August 6, 2021

RE: **Lot 27 Block 8 Unit 22 SAD 228
6311 Petirrojo Rd. NW
Volcano Cliffs Subdivision
Revised Grading and Drainage Plan
Engineers Stamp Date 8/4/2021 (D10D003E27)**

DRAINAGE AND TRANSPORTATION INFORMATION SHEET (REV 6/2018)

ENGINEER'S SEAL	Lot 27 Blk 8 Un 22 VC 6311 Petirrojo Road NW	DRAWN BY DEM
DAVID SOULE NEW MEXICO 14522 REGISTERED PROFESSIONAL ENGINEER	GRADING AND DRAINAGE PLAN	DATE 5-5-21
8/4/21	Rio Grande Engineering	Lot 27 Blk 8 Un 22 VC.DWG
DAVID SOULE P.E. #14522		SHEET # C1
		JOB #

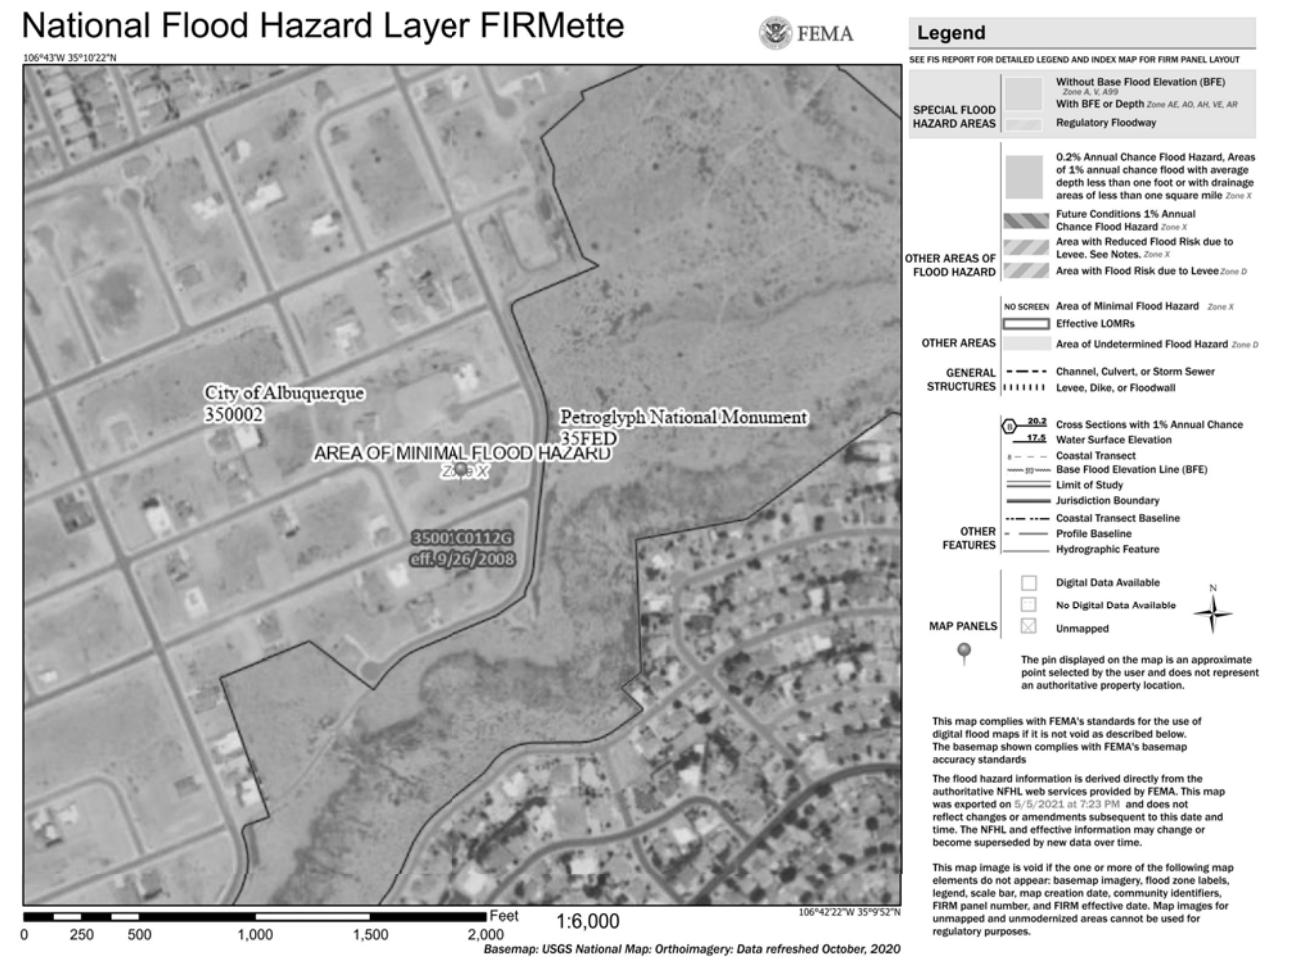
PO Box 1293
Based upon the information provided in your submittal received 8/4/2021, this plan is approved for Grading Permit. This will now be the plan used going forward.

Albuquerque
Prior to Building permit approval a Pad Certification will be required, provided by the Engineer or a registered Land Surveyor.

NM 87103
Advise the owner contractor not to use dirt as a ramp to climb the curb, use lumber or crusher fines for this purpose.

www.cabq.gov
Reiterate to the Owner/Contractor that a separate permit for a garden/retaining wall must be obtained with the approved G&D plan and Pad Certification. Also, if a swimming pool is to be placed after this approval a new grading and drainage plan will need to be resubmitted showing the changes for the land treatments.

Prior to Certificate of Occupancy release, Engineer Certification per the DPM checklist is required.
